#	Reference	Query / Question	Responses / Clarifications / Confirmation / Addendum
1.		We wish to request to extend the closing date of the tender by 2 weeks' time. Pls. consider that we have lost 1-week time of the process as the pre-bid meeting was postponed.	The closing date is to be extended one month to 8 <sup>th</sup> January 2026. Kindly refer to Addendum 3.

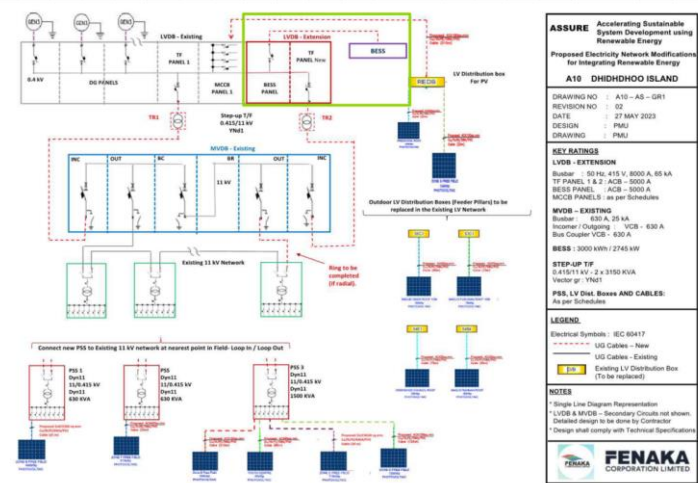
Per Section 3-3 and Section 3-4, the requirement for DC round-trip efficiency is  $\geq 80\%$ . However, Section 6-40 and Section 6-41 specify the requirement as  $\geq 85\%$  for the same indicator.  
Please clarify the definitive requirement value for DC round-trip efficiency.

There is inconsistency among several sections of the bidding documents. Please regard as follows.

DC roundtrip efficiency of flow BESS shall be  $\geq 80\%$ .

DC roundtrip efficiency of non-flow BESS shall be  $\geq 85\%$ .

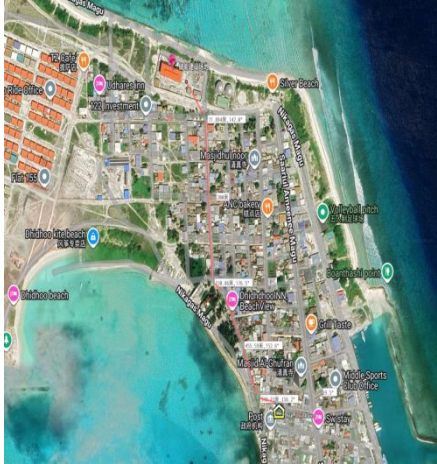
#	Reference	Query / Question	Responses / Clarifications / Confirmation / Addendum
		 <p>The drawing is a technical schematic for an electrical network. It features a main single-line diagram at the top showing the connection between a 6.4 kV bus, DE PANELS, LVDB - Existing, BESS, and Step-up T/F. Below this, there are detailed diagrams for the LVDB - EXTENSION and MVDB - EXISTING. A legend defines symbols for LVG Cables (New and Existing) and LV Distribution Boxes. Technical specifications for BESS, STEP-UP T/F, and PSE, LV Dist. Boxes AND CABLES are provided. The FENAKA logo is visible at the bottom right of the drawing area.</p> <p>"Based on the description in the 'Installation Works and Services' section of Plant 1S2E Section4( Page [17]), the scope of work for this tender is limited to connecting to the low-voltage distribution panel. However, reviewing the main single-line diagram provided by the Employer, it indicates that a new outgoing cabinet needs to be installed for the low-voltage panel to connect to the new step-up transformer. We request confirmation on whether the new outgoing cabinet and its outgoing cables fall within the scope of work for this tender."</p>

15		<p>2. Confirmation of Work Interface Demarcation for Procurement and Installation of PV Fiber Optic Communication Cables</p>	<p>As stated in the bidding document, the procurement and installation of PV communication optical cables for both islands are entirely excluded from the tender scope.</p>
